# UNITED STATES PATENT AND TRADEMARK OFFICE

APPLICATION NO.	FILING DATE	FIRST NAMED INVENTOR	ATTORNEY DOCKET NO.	CONFIRMATION NO.
10/732,942	12/11/2003	Rita L. Faunce	211552-00050	7274

<b>Office Action Summary</b>	<b>Application No.</b> 10/732,942	<b>Applicant(s)</b> FAUNCE ET AL.	
	<b>Examiner</b> Samuel Berhanu	<b>Art Unit</b> 2838

**DETAILED ACTION*****Claim Rejections - 35 USC § 102***

**Figure B**

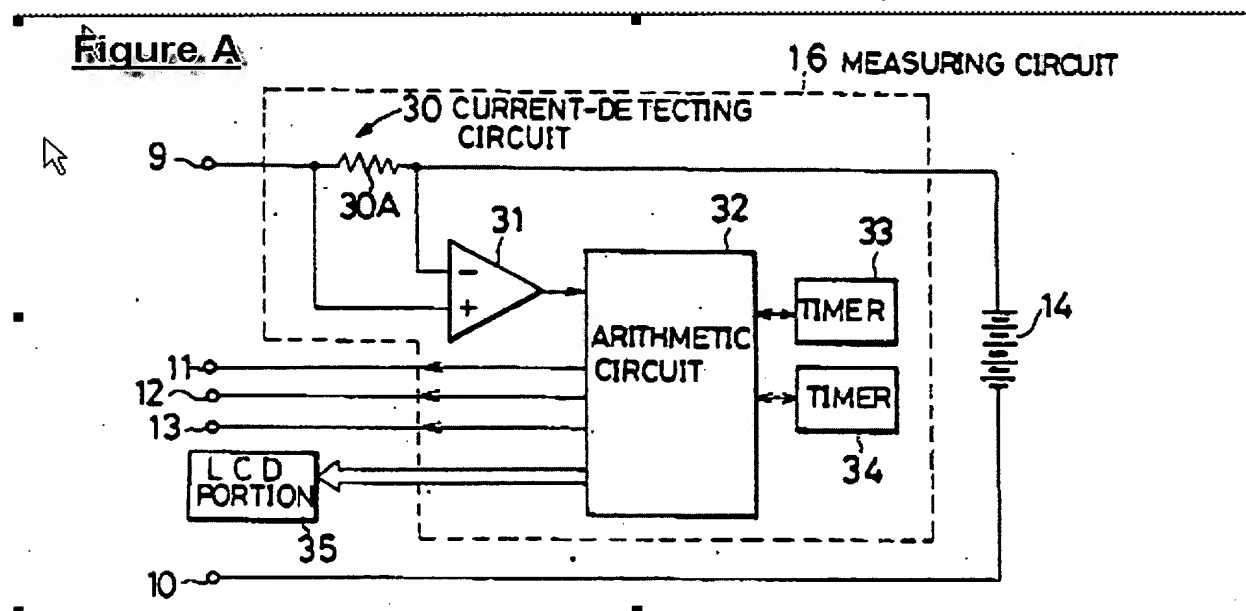
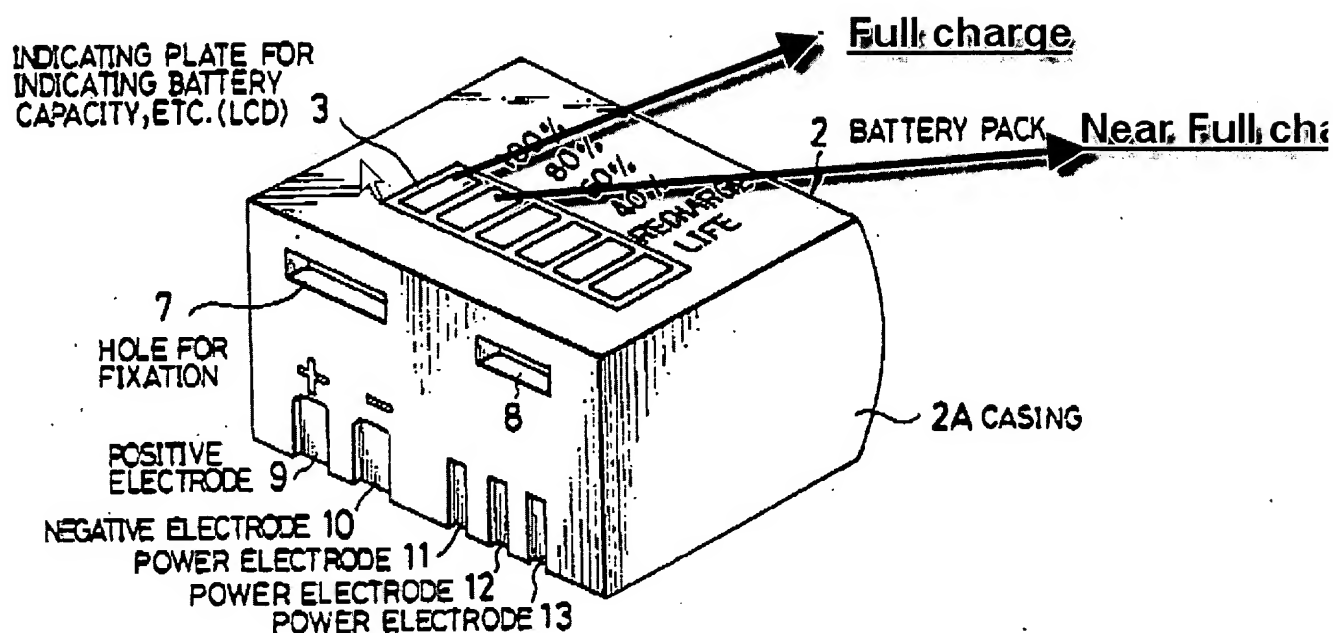
Regarding Claim 1, Nagai discloses in Figures 1-9, a battery charge indicator for sensing and indicating a near full state of charge of a battery, the battery charge indicator comprising:-

a sensing circuit (30) for sensing charging current to said lithium ion battery and providing a first charge indication Signal (element 3, LCD see figure 3) independent of whether said lithium ion battery in a constant current or constant voltage charging state and independent of the voltage of said lithium ion battery (**Nagai discloses in Figure 1 element 1 and Column 3, lines 56-61 that the battery 14 is a rechargeable battery, since Lithium battery is a rechargeable battery, it is believed that Lithium battery is disclosed implicitly by Nagai**) , when said charging current is less than a first predetermined value, said first predetermined value selected to be greater than the value of charging current of said lithium ion battery in a fully charged state (100%) said

sensing circuit generating a first charge indication signal (**80% indication signal see figure B above**) when said charging current is less than or equal to said first predetermined value, said first predetermined value representing a near full state of charge (**100% charge state of the battery**) of said lithium ion battery and an indicator (**LCD indicator to show the 80% charge of the battery see figure B above**) responsive to said first charge indication signal for providing an indication when said lithium ion battery is at a near full state of charge (**the indication of 80%**).

Regarding Claim 6, Nagai discloses in Figures 1-9, including a second visual indication (figure 3 and see figure B above).

Regarding Claim 7, Nagai discloses in Figures 1-9, wherein said sensing circuit is configured to generate one or more charge indicating signals selected from the group indicating signals from the group indicating that the state of charge of said battery is at a size of charger near full charge; at full charge or between said near charge state and said fully charge state (please see figure B above).
